ADDENDUM TO DRAINAGE AND SUDS STRATEGY - RESPONSES TO LLFA

LAND TO THE WEST OF FROGHALL LANE

ESSEX 2015121

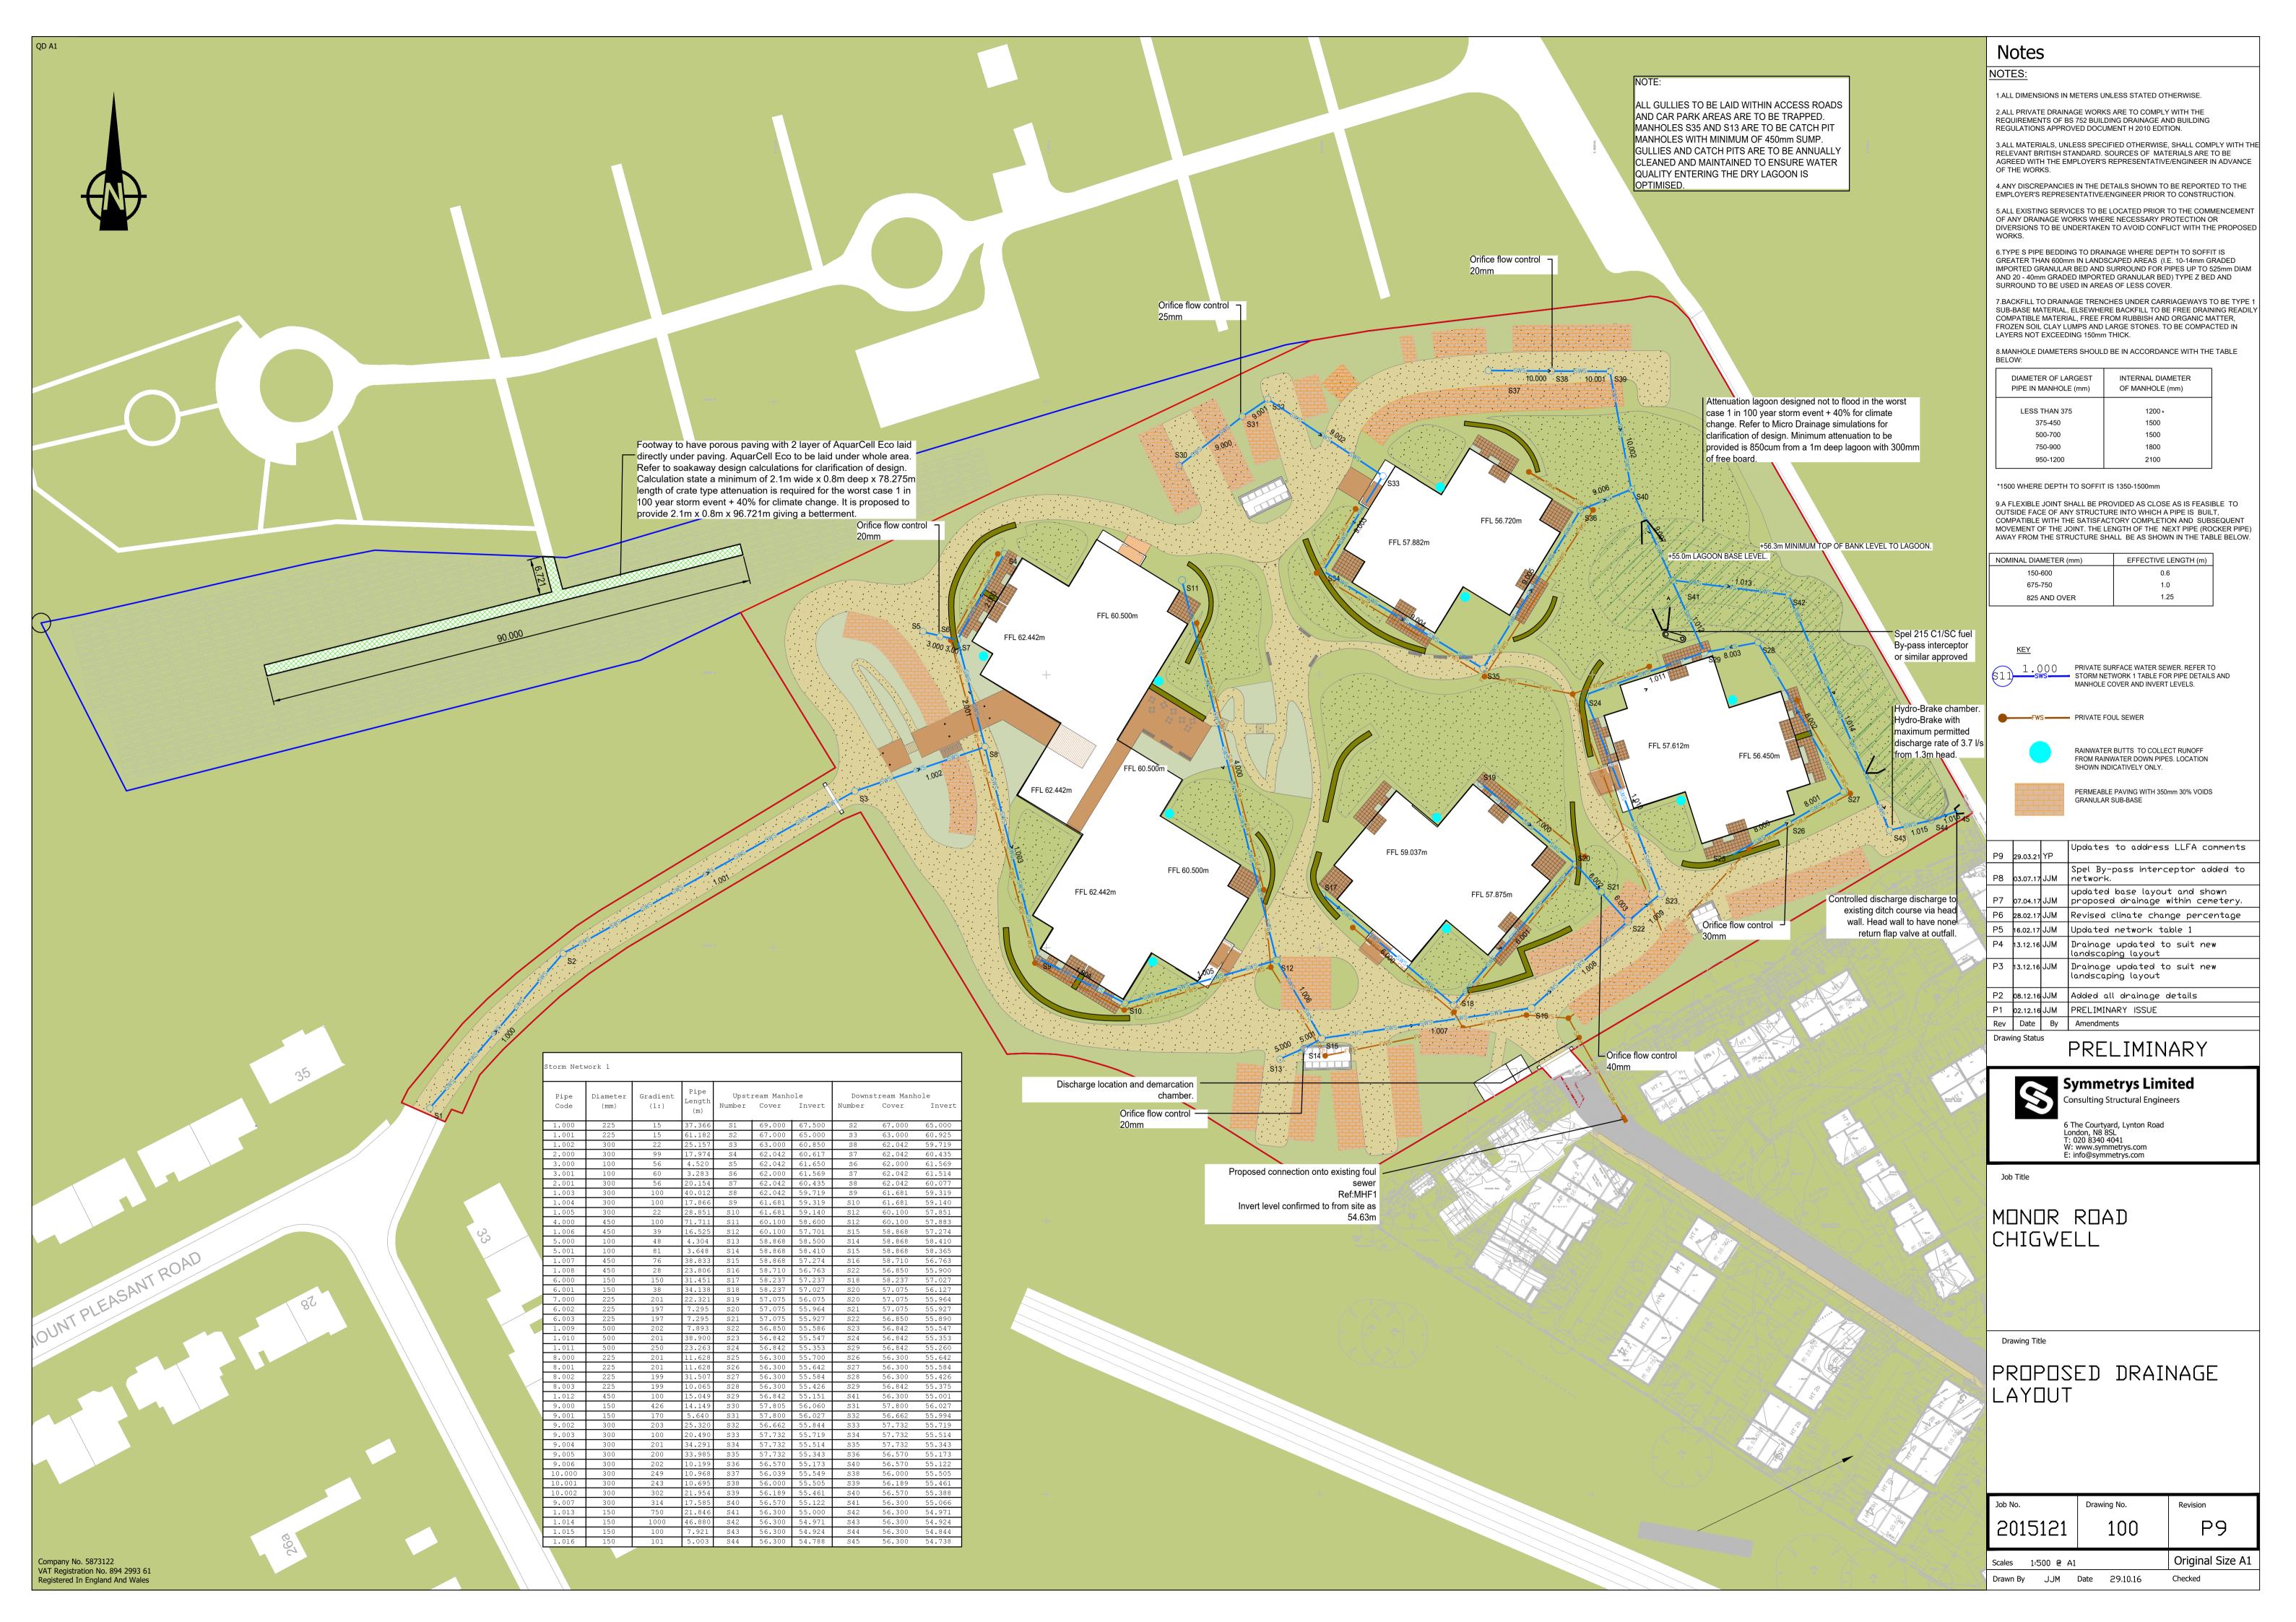
LLFA Comment	Responses	Amendments
1	Rainwater harvesting should be utilised	Rainwater harvesting butts will be provided to re-use water for garden planting watering. Strategy is limited to above ground due to the relatively high environmental impact of below ground tanks	Appendix A - Proposed Drainage Layout
2	Source control SuDS	Permeable paving is provided at parking spaces. Also, greenroof is proposed at the communal area building between Villas A and C	Appendix A - Proposed Drainage Layout
3	Runoff calcs for the areas discharging through SuDS only	The proposed runoff has been calculated following LLFA comments to only account for the impermeable areas. New value is 3.43 l/s/ha, 3.6 l/s for the 1.036 Ha of impermeable surfaces	Appendix B - Micro drainage Simulation Calculations 1 in 100 year + 40% and Greenfield Calculation.
4	Discharge from site restricted to 1 year GF, instead of 5 l//s	Drainage system has been re-calculated for the new proposed runoff rate of 3.7 l/s to match greenfield rates. This value is marginally higher than the calculated 3.6 l/s, to enable a half drain time of less than 24 hours for the 1 in 30 +40% storm event	Appendix A - Proposed Drainage Layout Appendix B - Micro drainage Simulation Calculations 1 in 100 year + 40% and Greenfield Calculation.

5	half empty in 24hrs for 1 in 30+40%	Calculations shown half drain time for the 1 in 30 + 40% climate change storm event is 1406 minutes (23.4 hours)	Appendix B - Micro drainage Simulation Calculations 1 in 100 year + 40% and Greenfield Calculation.
